HISTORIC AND DESIGN REVIEW COMMISSION

June 19, 2019

HDRC CASE NO: 2019-336
ADDRESS: 405 GILLESPIE
LEGAL DESCRIPTION: NCB 1745 BLK 8 LOT S 51.5 FT OF N 103 FT OF 5 E IRR 7FT OF MID PART OF 5 & 6
ZONING: R-6, H
CITY COUNCIL DIST.: 1
DISTRICT: Tobin Hill Historic District
APPLICANT: Jake Forshpan/FORSHPAN JAKE B & FORSHPAN SHARON K
OWNER: Jake Forshpan/FORSHPAN JAKE B & FORSHPAN SHARON K
TYPE OF WORK: Side porch modifications
APPLICATION RECEIVED: June 03, 2019
60-DAY REVIEW: August 02, 2019
CASE MANAGER: Huy Pham

The applicant is requesting a Certificate of Appropriateness for approval to remove the existing side porch to reconstruct a new enclosed side porch with similar architectural details.

Design elevation

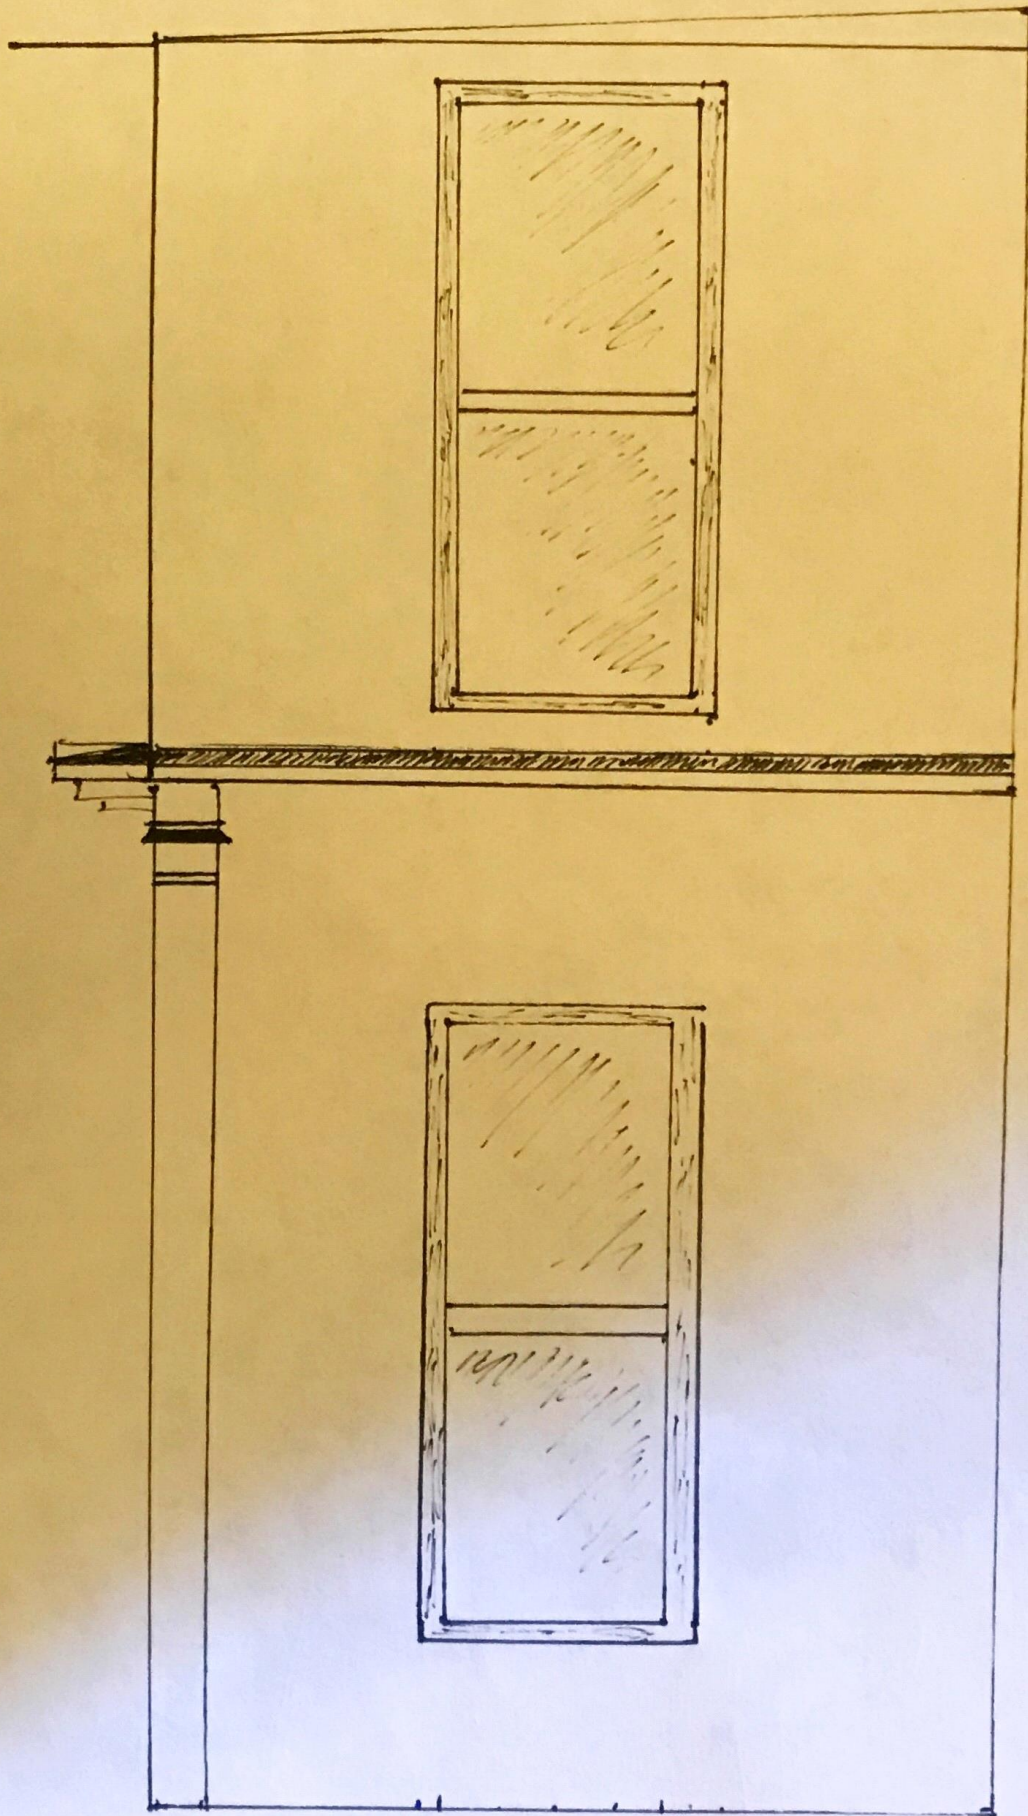
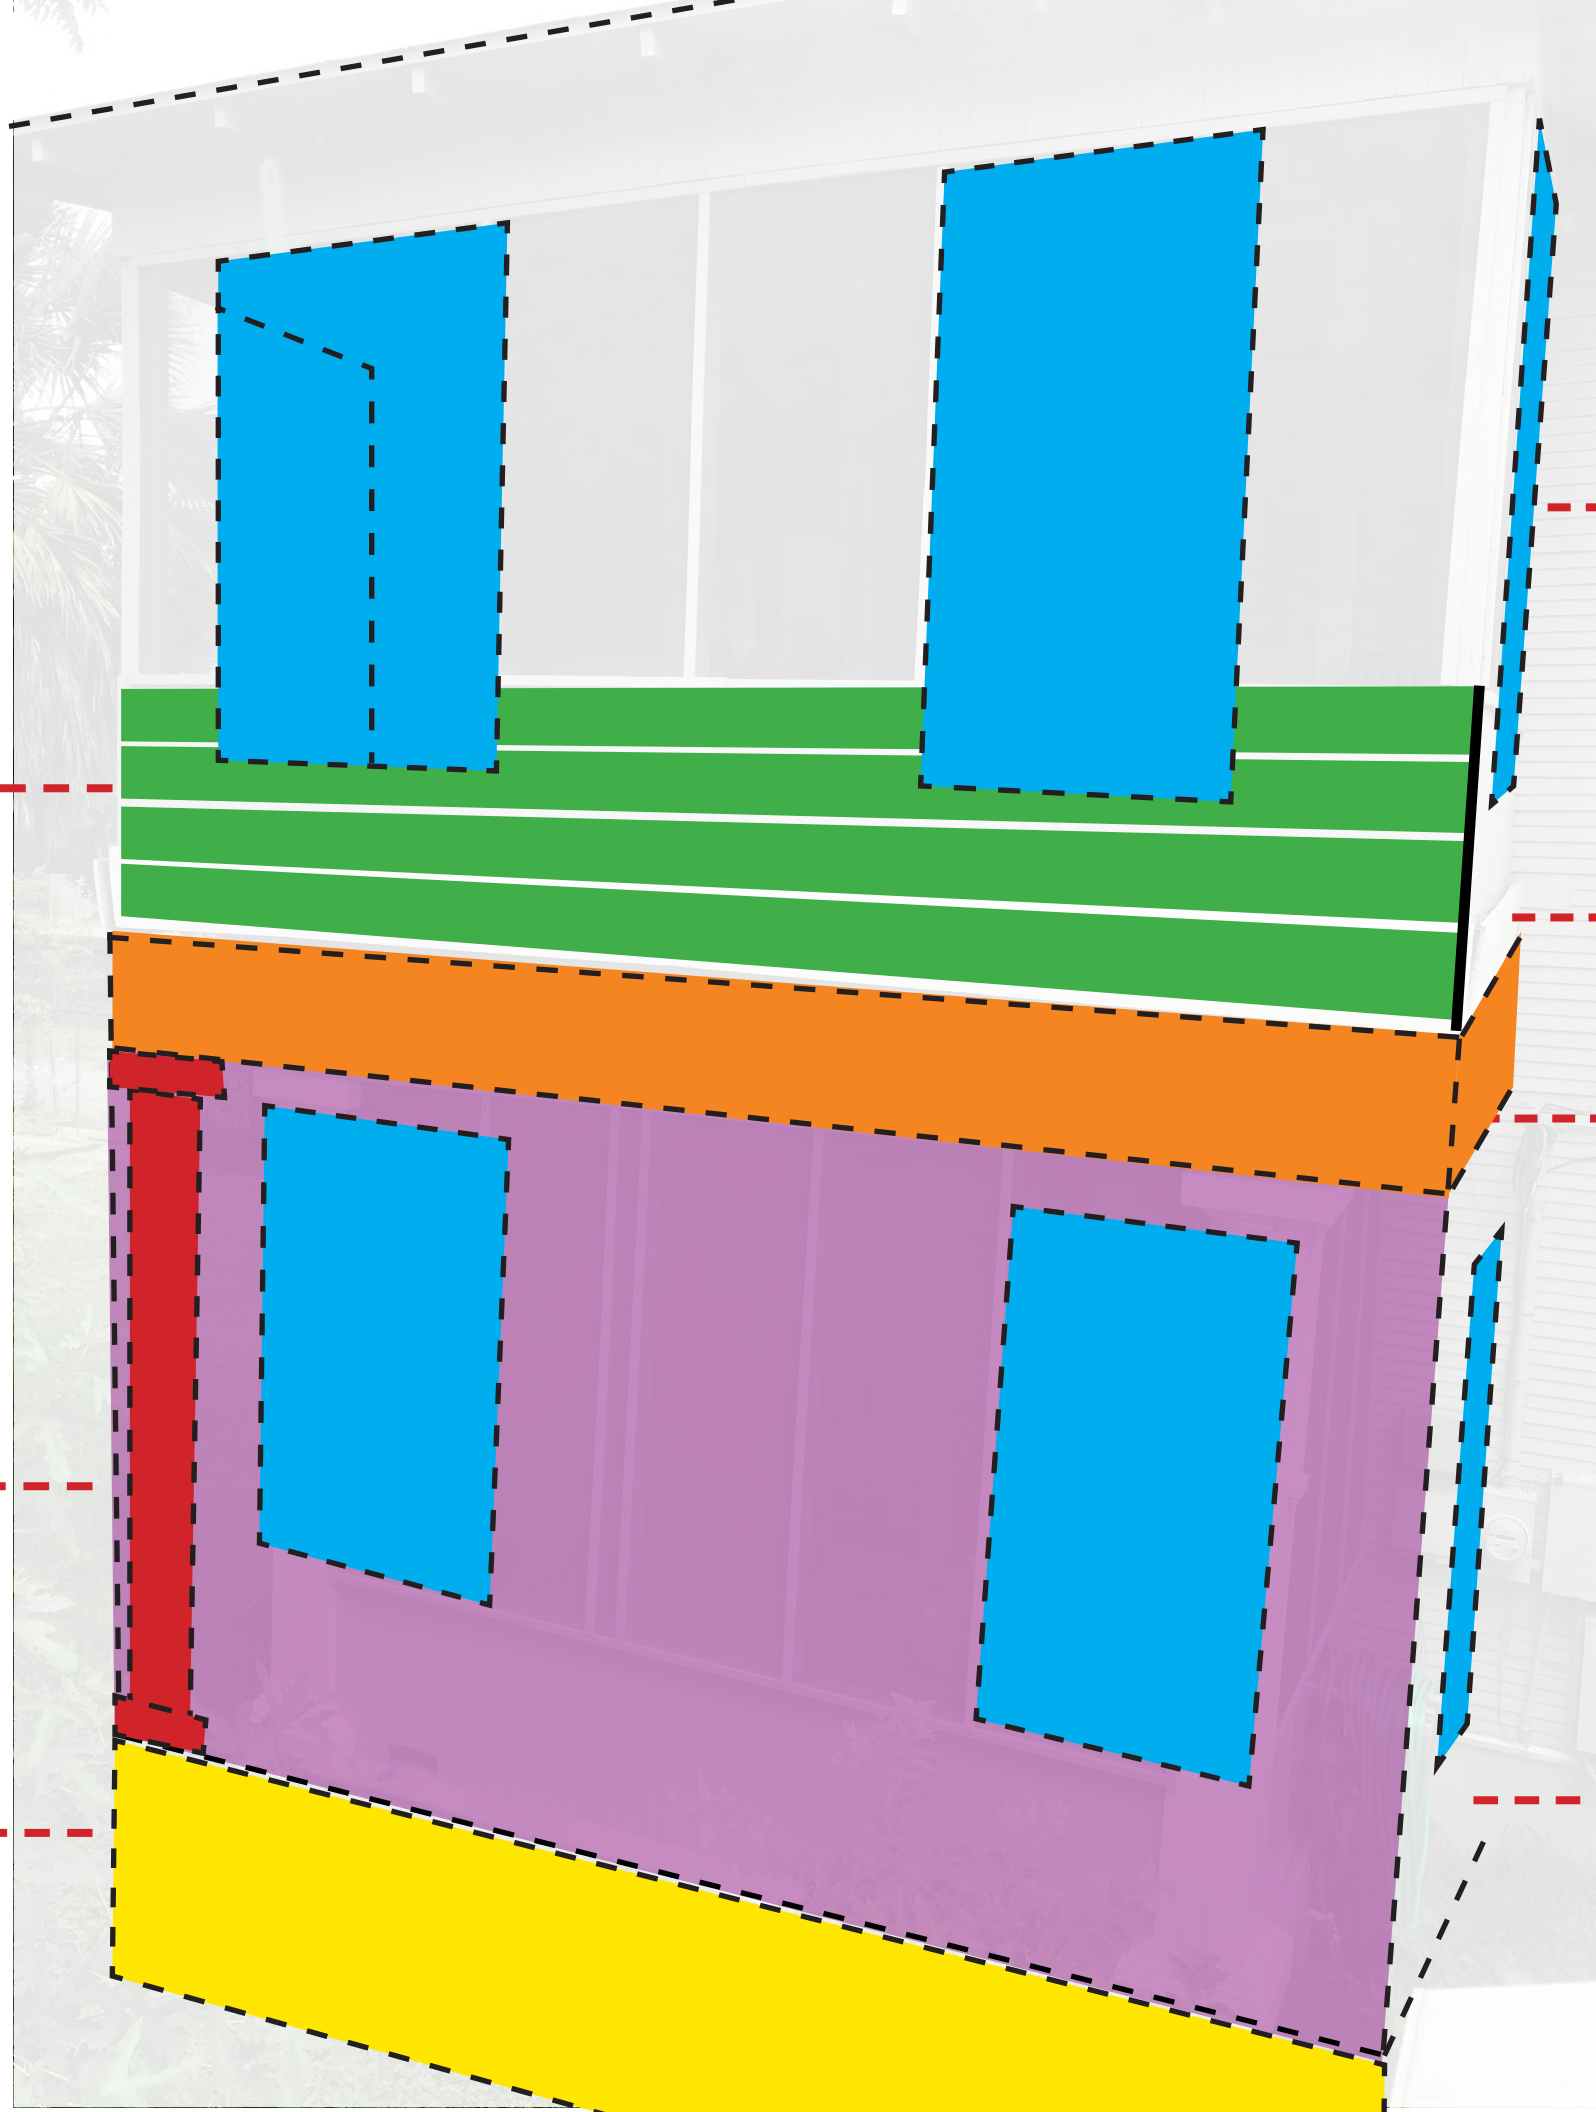
- d. **MODIFICATION** – The applicant has proposed to reconstruct the side porch as an enclosed addition with matching wood windows and lap siding to match the primary structure. The reconstruction requires relocating the original inset location of the columns by 16 inches each to meet flush at the corner of the balcony. The proposed side porch will also feature a matching fascia between the first and second floor matching the front façade detail. The original shed roof will remain in place and be used as a reference for the reconstructed footprint.

- e. **ENCLOSURE** – Per the Guidelines for Exterior Maintenance and Alterations 7.B.ii., one should refrain from enclosing side and rear porches, particularly when connected to the main porch or balcony. Additionally, the guidelines note that original architectural details should not be obscured by any screening or enclosure materials and that alterations to side and rear porches should result in a space that functions. Enclosed side and rear porches should appear as porches. Staff finds that the enclosure of this side porch to be generally appropriate given that it is not connected to the main porch; however, staff finds that architectural elements such as the columns should not be removed or obscured and that the space should still function and be visually interpreted as a porch.

- f. **RECONSTRUCTION** - Additionally, per the Guidelines for Exterior Maintenance and Alterations 7.B.v. the reconstruction of porches, balconies, and porte-cocheres should be based on accurate evidence of the original, such as photographs. If no such evidence exists, the design should be based on the architectural style of the building and historic patterns on the block. Staff finds that photographic evidence does exist, and in-kind reconstruction should be considered prior to relocating original columns and enclosing open spaces with siding.

Staff does not recommend approval as proposed based on finding b through f. Staff recommends an in-kind reconstruction based photographic evidence to match in footprint and fenestration details. A first floor enclosure may be appropriate while the already screened second-floor balcony should be restored in-kind.

If the commission is compelled to approve the reconstruction as proposed including the relocation of porch columns, the installation of lap siding on the first and second floor, and the installation of wood windows and doors, staff recommends the following stipulations:

- i. The new siding should match the existing structure (117 profile).
- ii. The new wood windows should match the existing windows in size, type, configuration, material, form, appearance, and details including the standard stipulations: *Meeting rails that are no taller than 1.25” and stiles no wider than 2.25”. White manufacturer’s color is not allowed, and color selection must be presented to staff. There should be a minimum of two inches in depth between the front face of the window trim and the front face of the top window sash. This must be accomplished by recessing the window sufficiently within the opening or with the installation of additional window trim to add thickness. Window trim must feature traditional dimensions and an architecturally appropriate sill detail. Window track components must be painted to match the window trim or concealed by a wood window screen set within the opening.*

- iii. The original columns and fascia details should be incorporated into the new side enclosed porch addition.
